UK-3187.30-1-27
Kroger Field Repairs 2027
ADDENDUM #1
11/03/2026

Addendum No. 01

University of Kentucky
Kroger Field 2027 Repairs Concrete & Waterproofing
3187.30
25130.00
November 3, 2026

DRAWING NUMBER: 102C

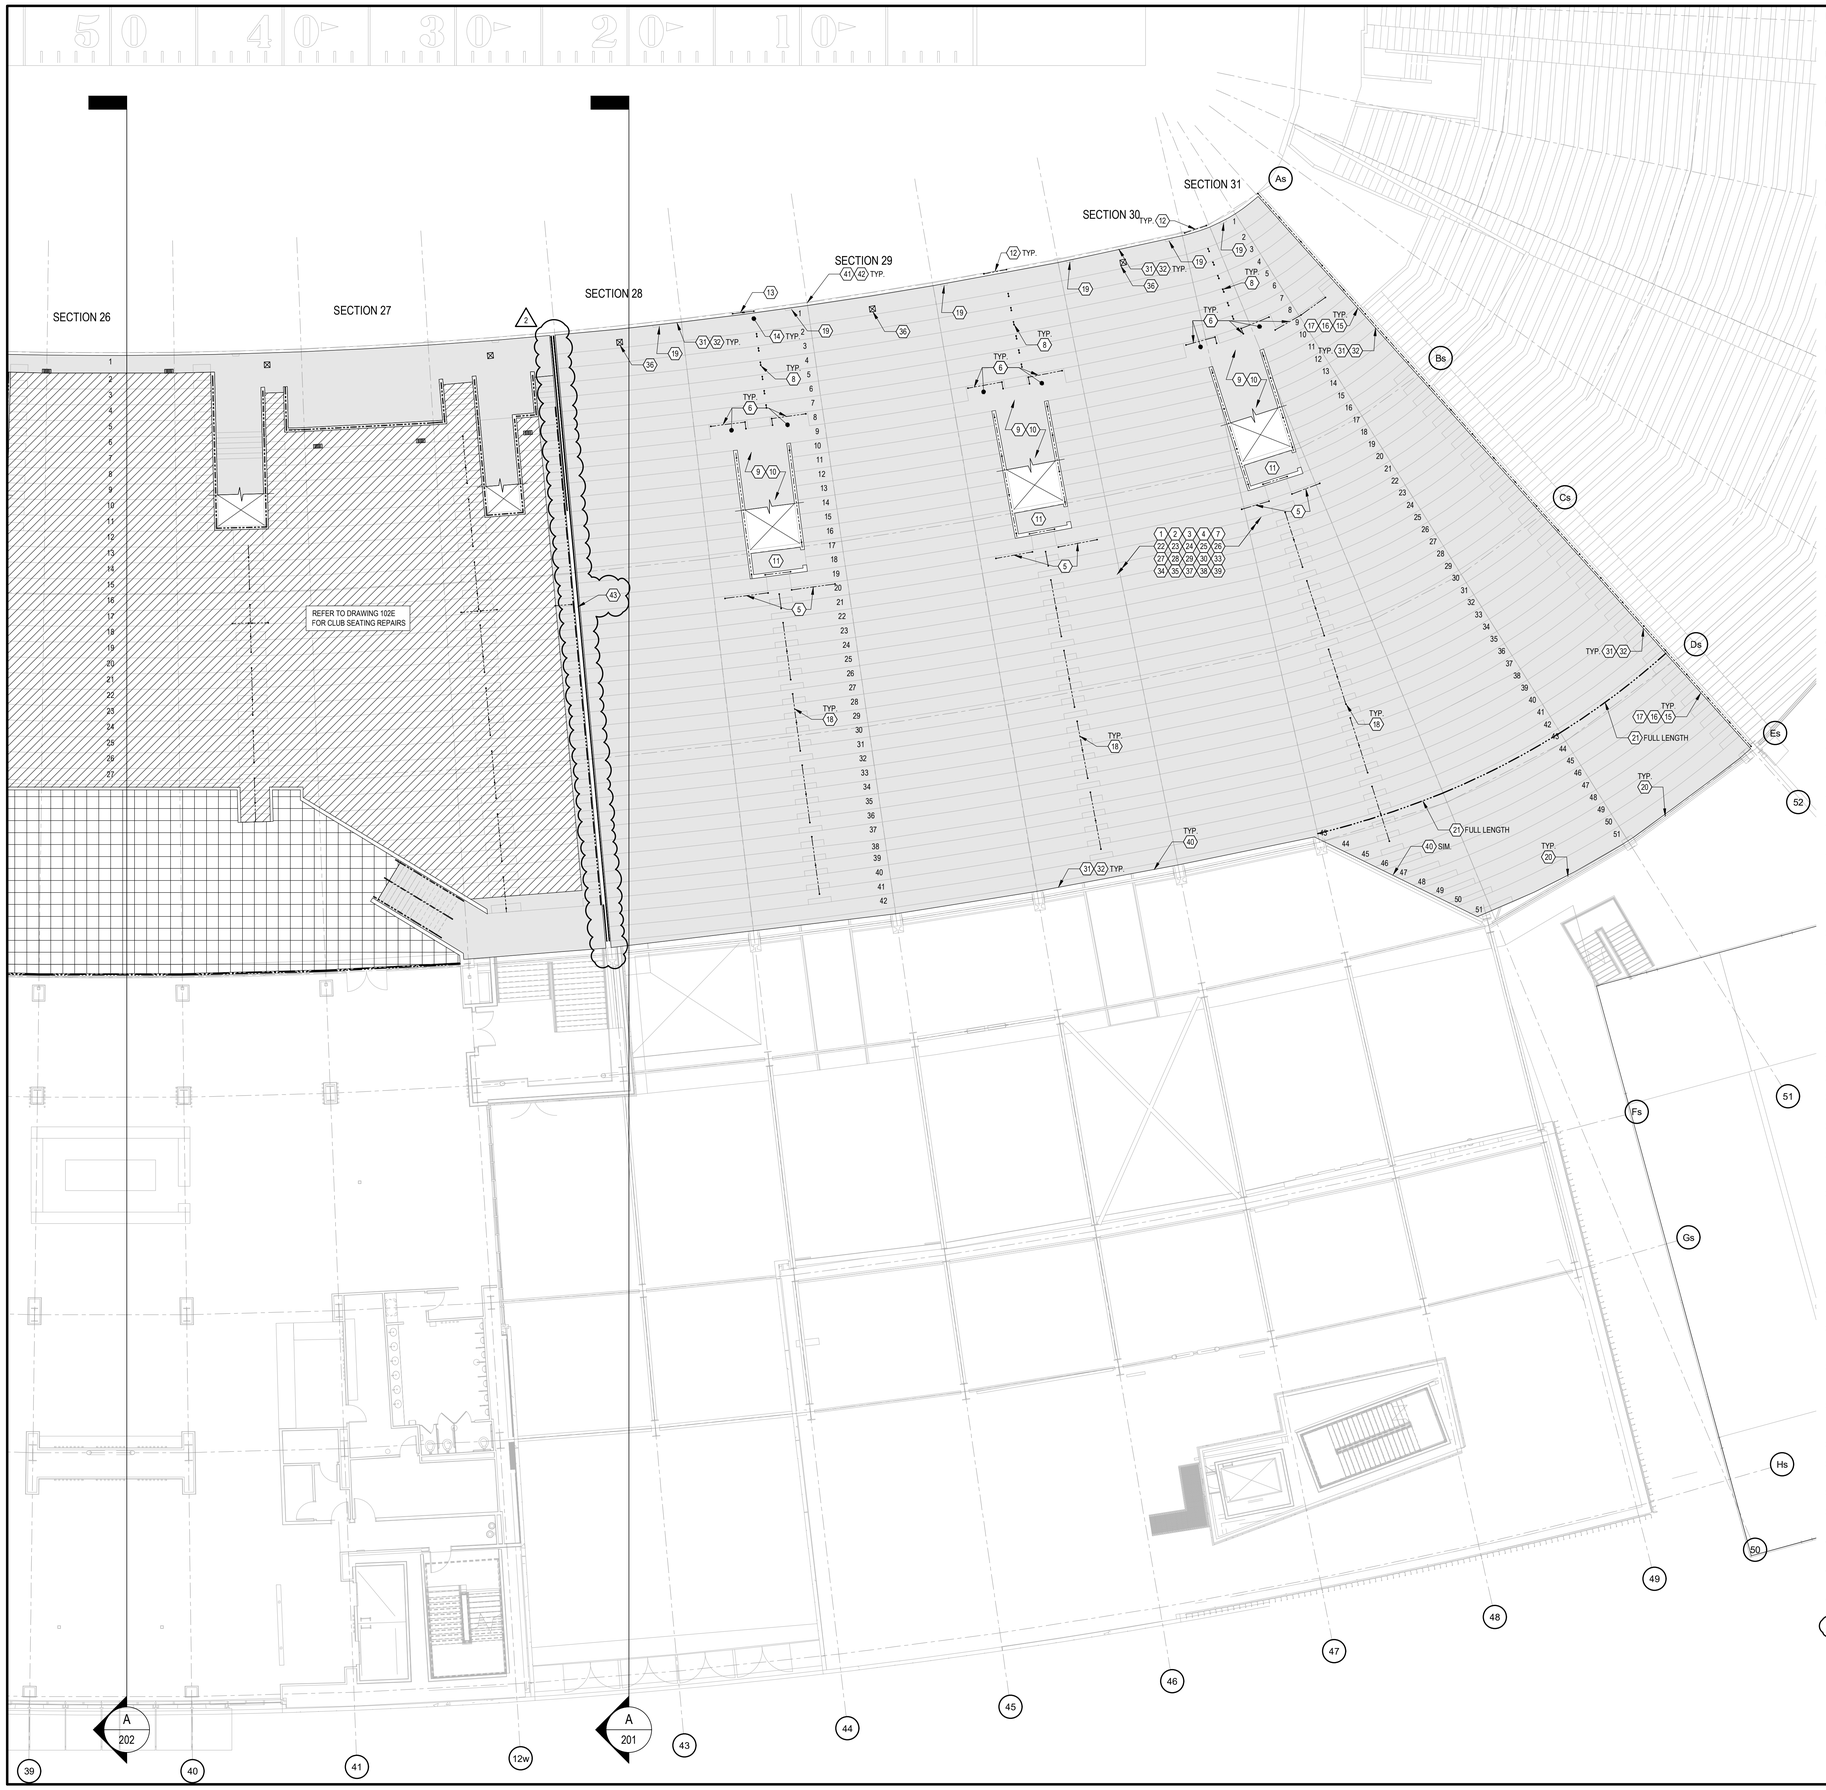
1. 102C: Reissued this drawing.
    a. Key Note 43 added to this drawing.
2. 102D: Reissued this drawing.
    a. Key Note 43 added to this drawing.
3. 102E: Reissued this drawing.
    a. Key Note 29 modified.
    b. Key Note 31a and 31b added to this drawing.
4. 304: Reissued this drawing.
    a. Detail 39/304. Added Key Note 8 to this detail.
    b. Detail 41/304. Changed this detail to show the new railings.

42. DRAINAGE TRENCH ALL BASE OF FRONT WALL OF LOWER BOWL. UPON COMPLETION OF WORK CLEAN DRAINAGE TRENCH. REFER TO PHOTO DETAIL 31/303.
43. REFER TO DRAWING 102E FOR WALL RAILING WORK.
